BWROG-12028
June 13, 2012

SUBJECT: Submittal Responses to Request for Additional Information Regarding Boiling Water Reactor Owners' Group (BWROG) Licensing Topical Report BWROG-TP-11-023, Revision 0, Linear Elastic Fracture Mechanics Evaluation of General Electric Boiling Water Reactor Water Level Instrument Nozzles for Pressure-Temperature Curve Evaluations (TAC NO. ME7650)

Responses to Request for Additional Information Regarding Boiling Water Reactor Owners' Group (BWROG) Licensing Topical Report BWROG-TP-11-023, Revision 0, Linear Elastic Fracture Mechanics Evaluation of General Electric Boiling Water Reactor Water Level Instrument Nozzles for Pressure-Temperature Curve Evaluations (TAC NO. ME7650)

Figure 1: 1/4t path stress distributions for CS and LAS WLI nozzle FEA and polynomial curve fit equations.

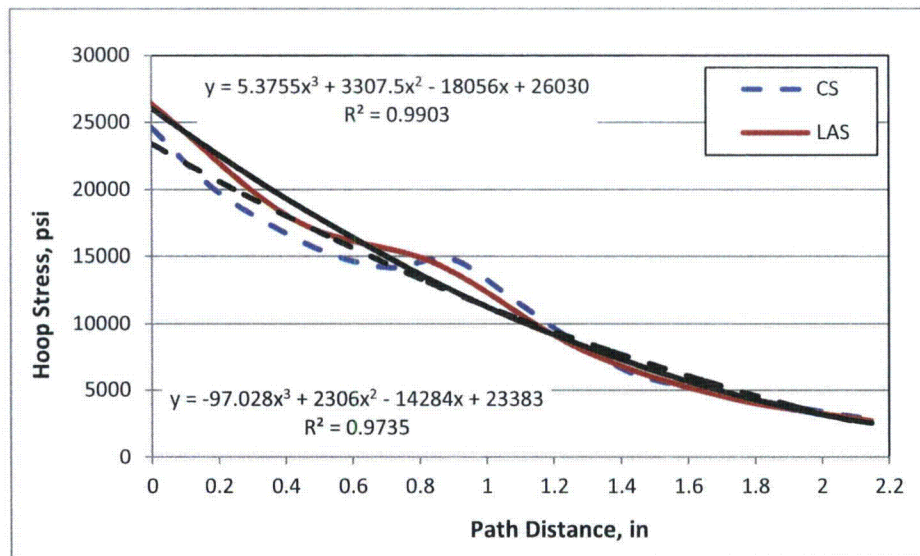
- It is stated that, "[s]ince there is no specific material specification identified for the CS [carbon steel] nozzle inserts from Table 2-1 of Reference [13], SA-541 Class 1 is assumed." Depending on the material properties used, this assumption could change the calculated stresses significantly. Please estimate the ranges of key material properties for CS nozzle inserts and assess the impact on the LTR results and conclusion, considering that each property could be at either end of its range.*

representative finite element analysis of a water level instrument nozzle configuration with LAS material properties was performed. The K_I from a 100 °F/hr cool-down transient was calculated and the difference in K_I obtained from the thermal transient for LAS and CS water level insert nozzle materials is evaluated. The modeling methodology described in the LTR was used for this evaluation; therefore, it is not documented here. Path stresses for each nozzle case were extracted over the first 1/4t path length, polynomial curve fit coefficients were calculated, and a K_{It} was determined using Eq. 2-1 of the LTR. The path length used for this study was 2.148 inches. Figure 1 shows the path stress distributions, over the first 1/4t and the polynomial curve fit equations. The results of this comparison are summarized below:

$$\begin{aligned} K_{IT_CS} &= 21.9 \text{ ksi-in}^{0.5} \\ K_{IT_LAS} &= 22.7 \text{ ksi-in}^{0.5} \\ \text{Ratio} &= 1.037 \end{aligned}$$

The detailed analysis shows that the effect of the different nozzle materials is less than 4%, which is considered to be within the accuracy of the inputs and overall methodology. Recognizing that the BIE/IF solution used in the LTR has been shown in Section 7 (See Table 7-1) to be conservative by 46% for the 100 °F/hr thermal ramp load case, the minor difference (less than 4%) in the K_{It} calculated using LAS or CS material properties is not considered to be significant.

Figure 2: Temperature distribution through the thickness of a flat plate over time, convection on one side and insulated on the other side, $h=500 \text{ BTU/hr-ft}^2\text{-}^\circ\text{F}$, CS material properties, $100 \text{ }^\circ\text{F/hr}$ cool-down transient.

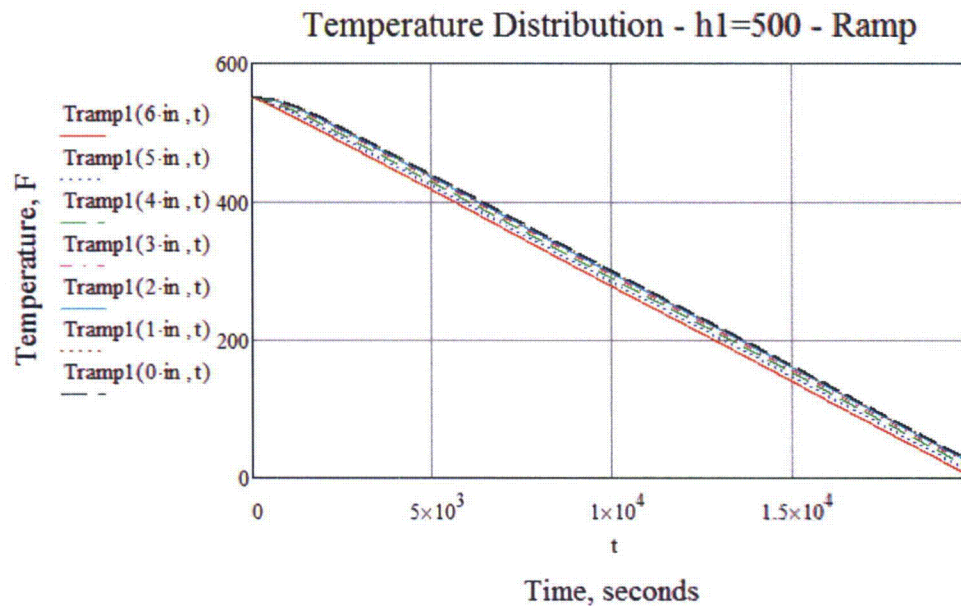
- In the thermal analysis, the heat transfer coefficient is assumed as 500 Btu/hr-ft²-°F for the inside surface of the vessel and nozzle and 0.2 Btu/hr-ft²-°F for the outside surface of the vessel and nozzle. Please justify the use of these coefficients in this application and cite NRC safety evaluations (SEs) accepting use of these coefficients in similar applications.*

The solution given in Eq. (1) is for the heat transfer problem of a flat plate with a convection coefficient on one side and an insulated boundary condition on the other side. The temperature distribution and through-wall temperature difference across the first 2 inches (the approximate $\frac{1}{4}$ wall thickness path length for the instrument nozzle) are shown in Figures 2 through 4 below for a $h = 500$ and $1000 \text{ BTU/hr-ft}^2\text{-}^\circ\text{F}$. The results shown in Figures 2 through 4 show that the temperature difference across the first $1/4T$ of the RPV wall does not experience a significant change whether a convection coefficient of $500 \text{ BTU/hr-ft}^2\text{-}^\circ\text{F}$ or $1000 \text{ BTU/hr-ft}^2\text{-}^\circ\text{F}$ is used in the evaluation. Further increase in the convection coefficient, above $500 \text{ BTU/hr-ft}^2\text{-}^\circ\text{F}$, will have no significant effect on the thermal stresses calculated for the evaluations performed in the LTR.

1. $x = 6$ inches corresponds to the surface on which the convection coefficient of $500 \text{ BTU/hr-ft}^2\text{-}^\circ\text{F}$ is applied.
2. $x=0$ inches corresponds to the insulated surface.
3. Ramp rate is $-100 \text{ }^\circ\text{F/hr}$.
4. For the purposes of this evaluation the ramp was not stopped at $70 \text{ }^\circ\text{F}$; hence the continuous decrease in temperature below $70 \text{ }^\circ\text{F}$.
5. Carbon steel material properties are used here; the results would be the same with LAS material properties.
